Value Engineering

Draft Report for Presentation

Removal of Elwha and Glines Canyon Dams, Elwha River Ecosystem and Fisheries Restoration Project

April 25, 2003

Figure 7. Schedule, sheet 2 of 2.

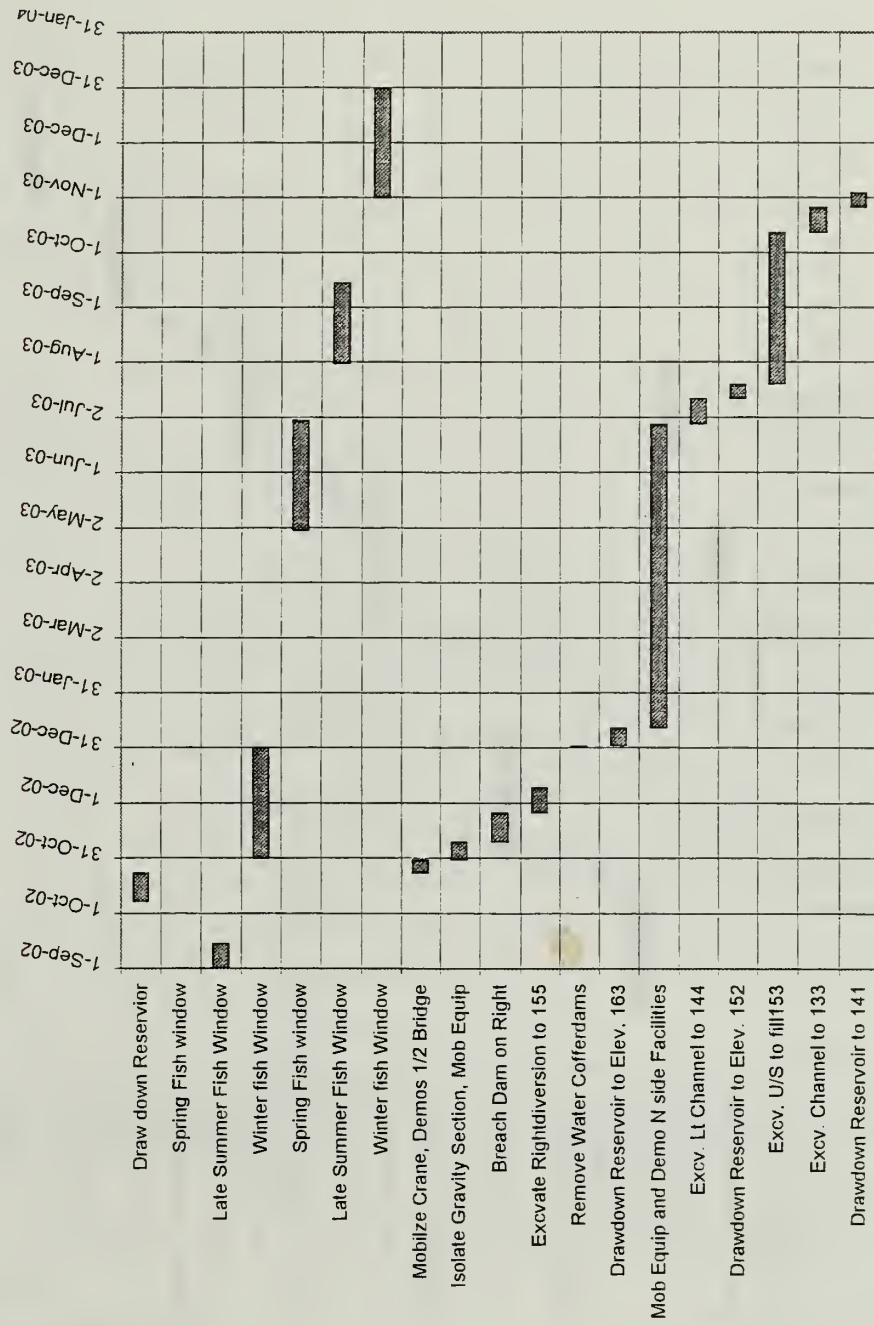
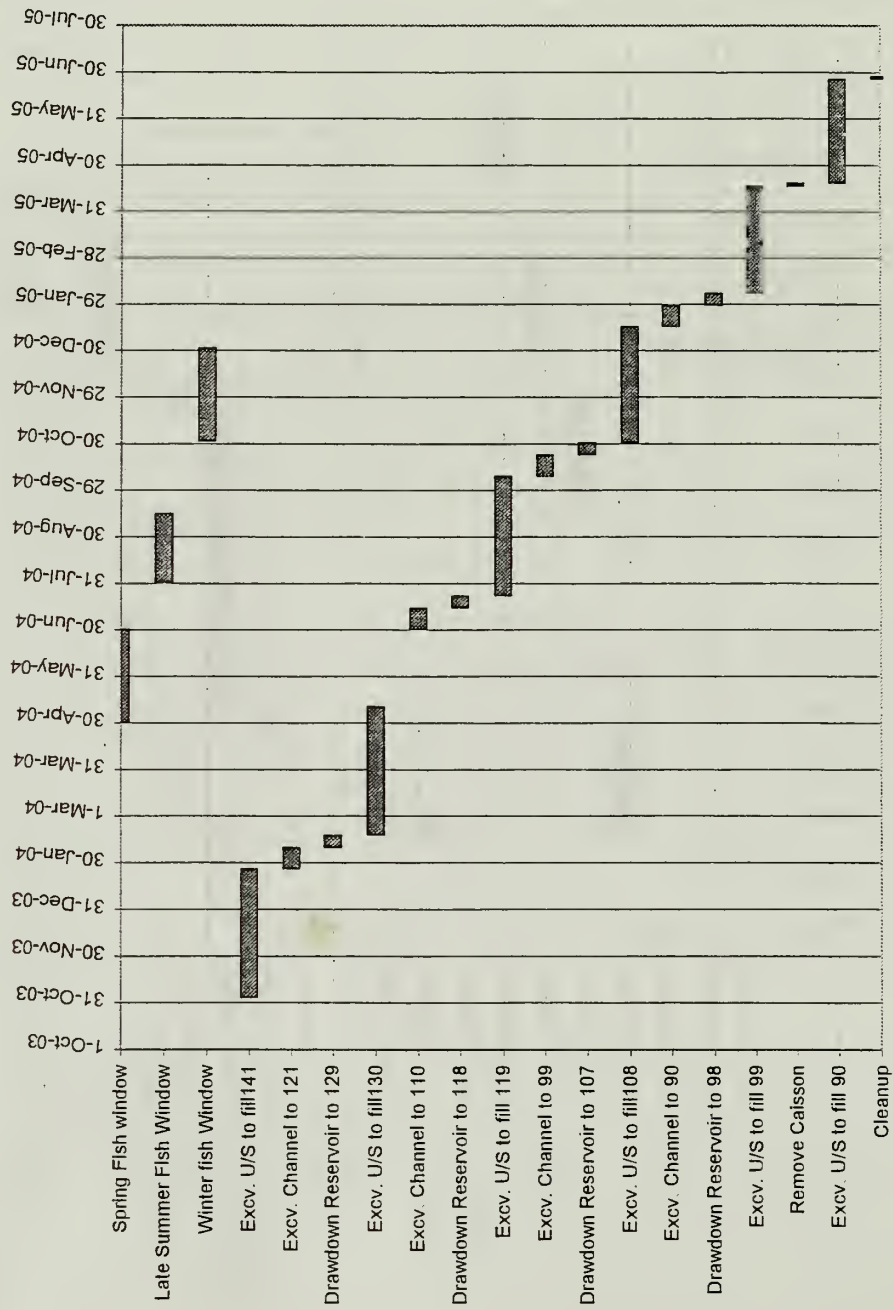
- Ways to Implement: See Figures 6 and 7 for schedule of implementation.
 1. Drawdown reservoir from El 197 to El 173+/- using Lt and Rt spillways and penstocks at a rate of 1 ½' per day limiting ramping to 1,000 cfs per hour. This is the same as the baseline but may be done following decommissioning of the power plant and before award of the contract.
 2. Mobilize crane to Rt spillway and demolish bridge/walkway over Rt spillway and Rt half of gravity dam.

Figure 8. Right Diversion Channel

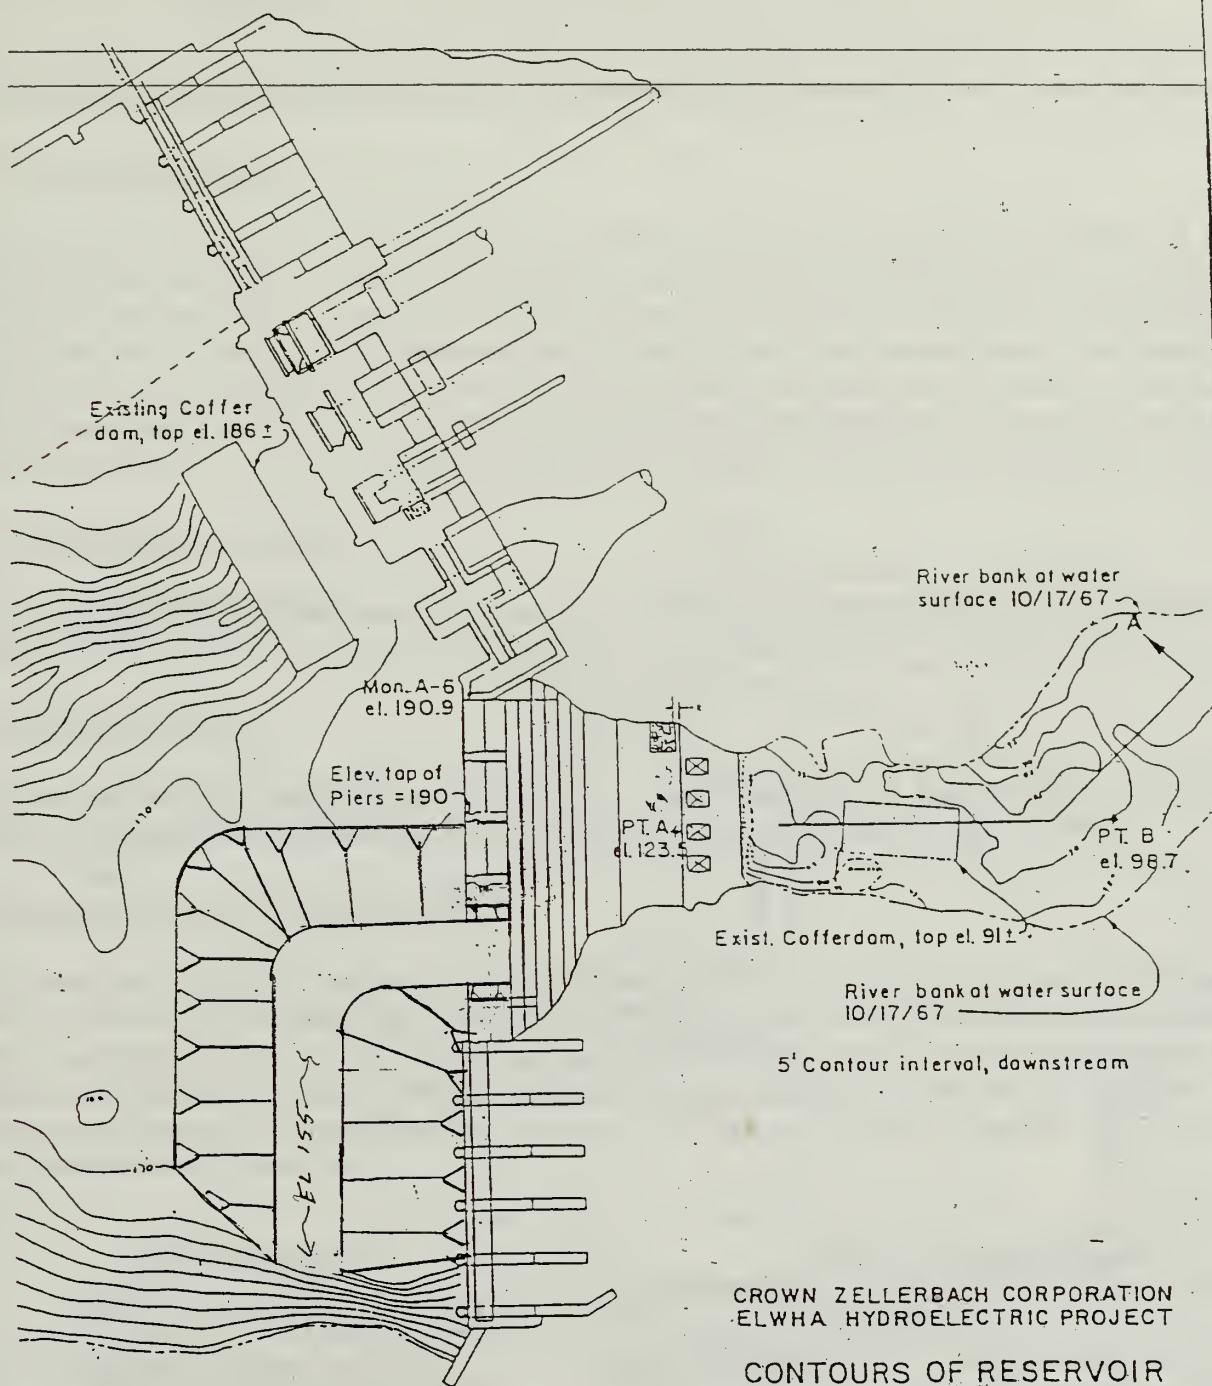
5. Demolish the right half of the dam and excavate adjacent upstream fill from El 194.5 to El 170.
6. Excavate diversion channel on Rt side through upstream fill and gravity section from El 170 to El 155 with bottom width of 20', side slopes of 2:1 through fill, and 1/4: 1 through dam. A plug will be left between the channel and reservoir. Figure 8 shows the completed diversion channel with out plugs.

Figure 9. Left Diversion Channel

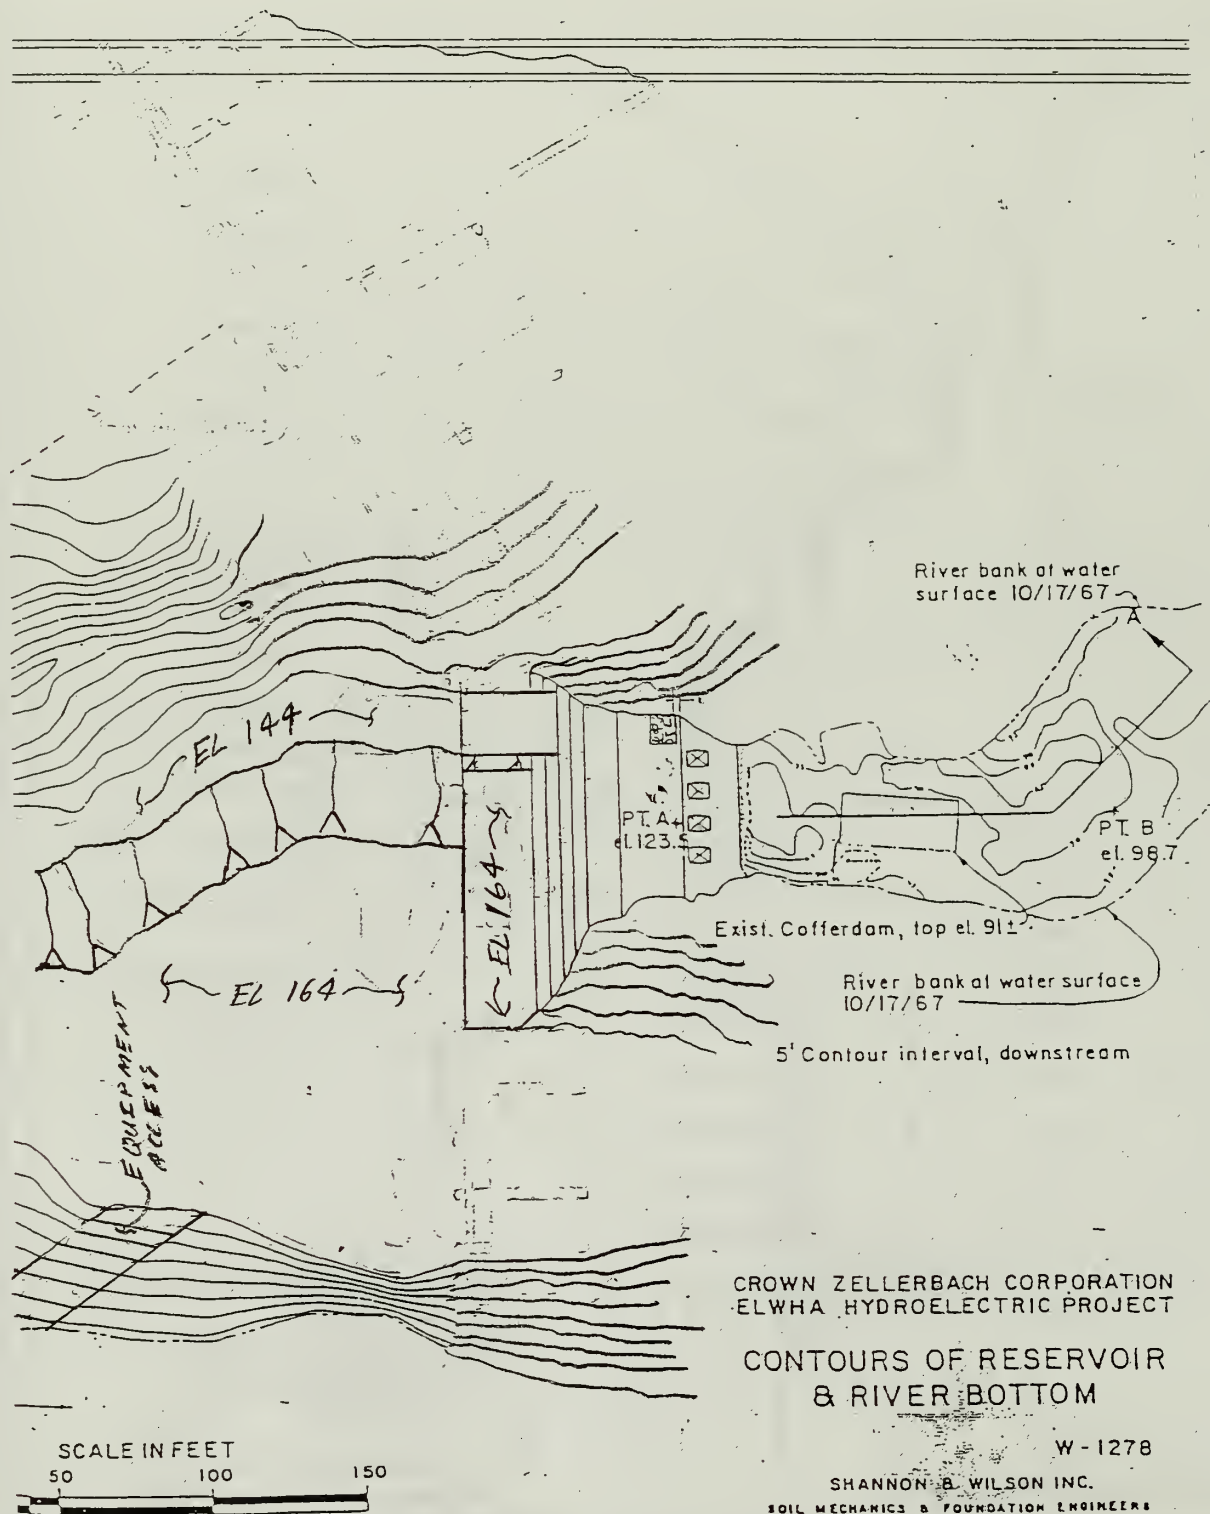
10. In conjunction with 8, and as equipment access requirements permit, excavate gravity dam from El 170 to El 164.
11. Excavate diversion channel on Lt abutment of the gravity dam through the upstream fill and the dam from El 164 to El 144. Leave plug between channel and reservoir and leave a section of the gravity dam crest in place from El 164 to 144. The concrete "plug" will prevent flows in the rock fill from moving to the left side prematurely. Figure 9 shows the completed diversion channel with out plugs.

Figure 10. Slope Contours, left side Elwha Dam.

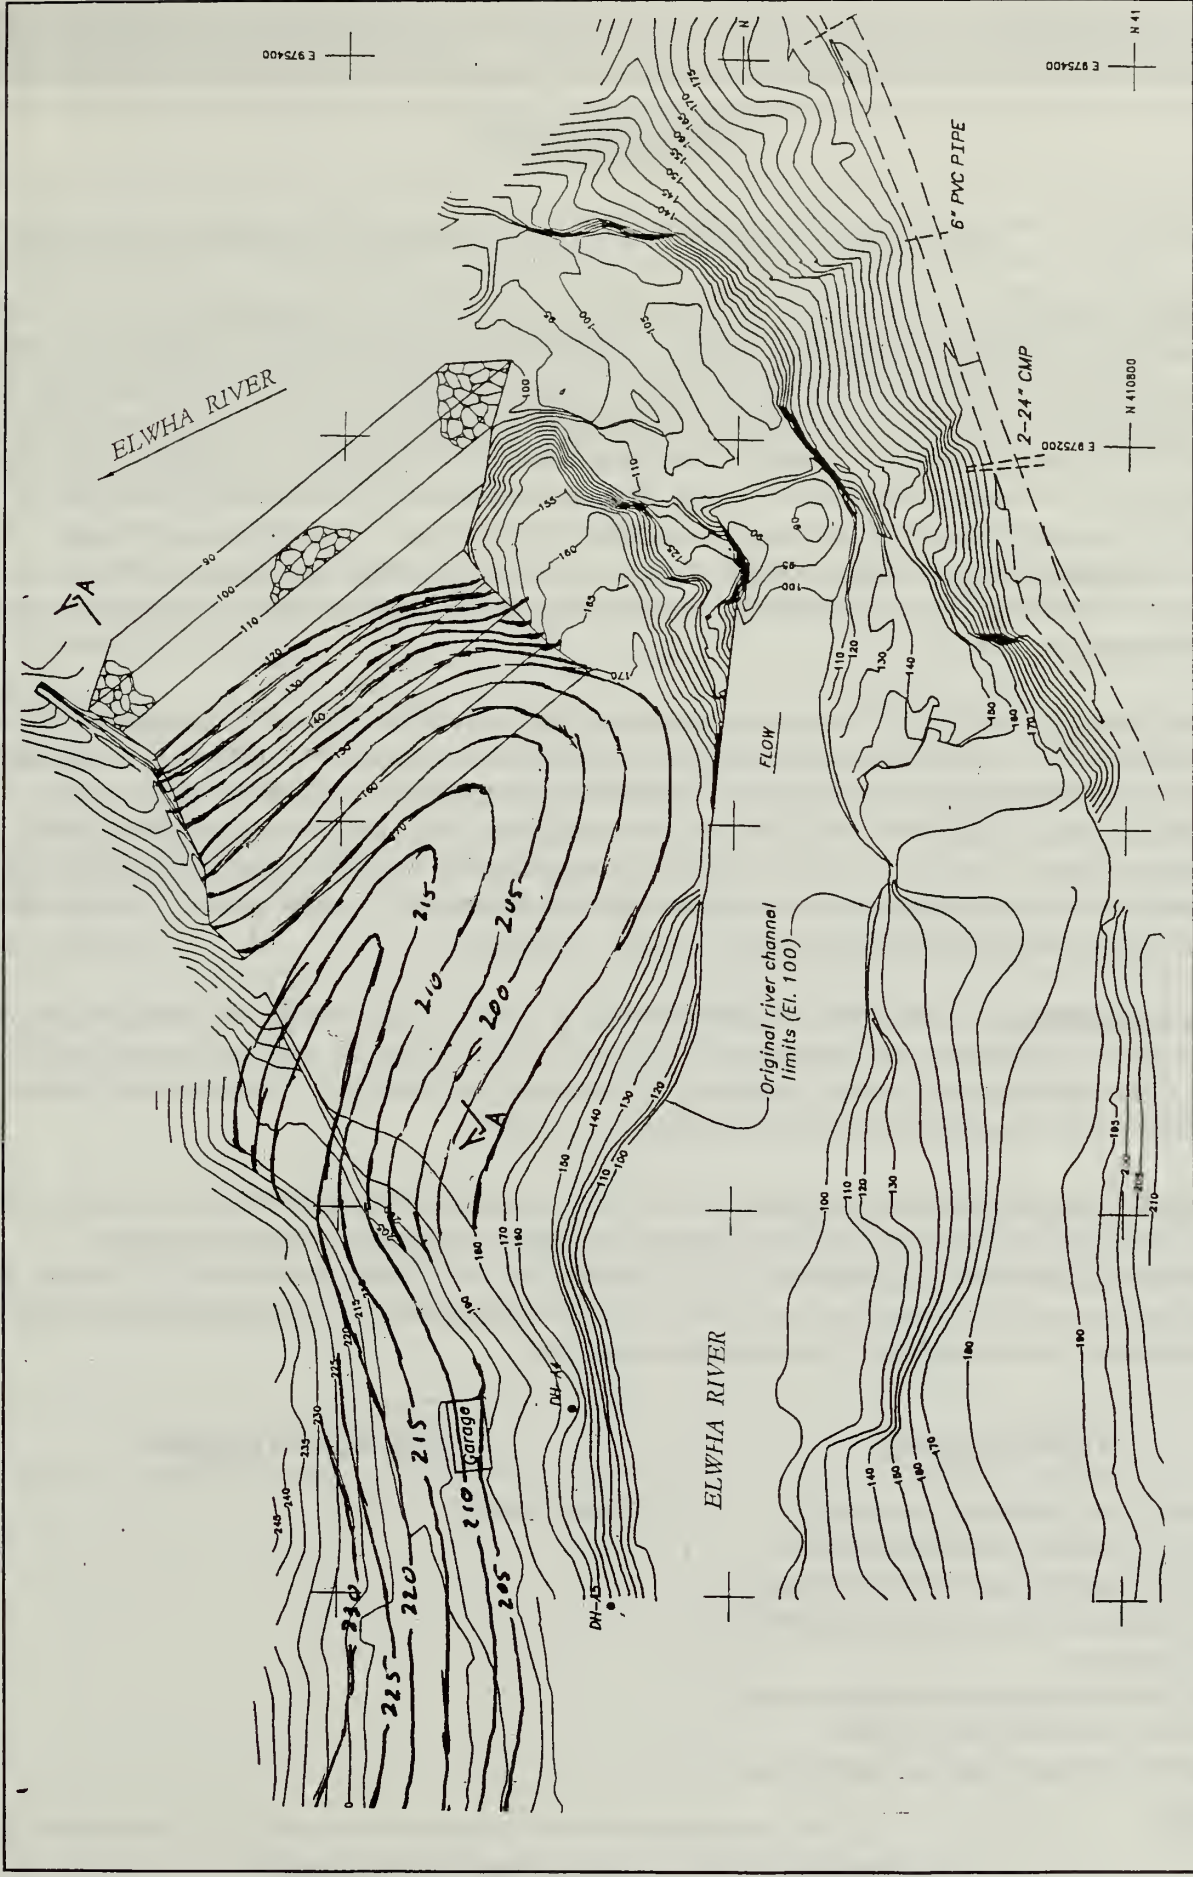
The proposal would be to create a “ridge” in the area of the left spillway and penstocks up to perhaps elevation 220+/- . See Figure 10. This would create a more natural looking topography and eliminate long distance hauling of approximately 50,000 cy of material. The proposal would leave portions of the left (north) spillway and intake in place and buried under the ridge of natural materials. The VE team feels that the uniformity of this area looks very un-natural, and feels that this area could be used as a waste area to dispose of lower spillway and intake structure concrete and cover with rock fill and other natural materials with minimum hauling required.

The Baseline Concept shows a large flat area at elevation 170 with a large uniformly sloped area down to the river at elevation 90. The VE Proposal is to use this area as a waste area to dispose of approximately 50,000 cy of material and at the same time create a more natural appearing hillside. Foundation portions of the spillway and intake structures would be left in place, eliminating the need for demolition and removal. The ridge of natural materials would be placed over the remaining concrete.
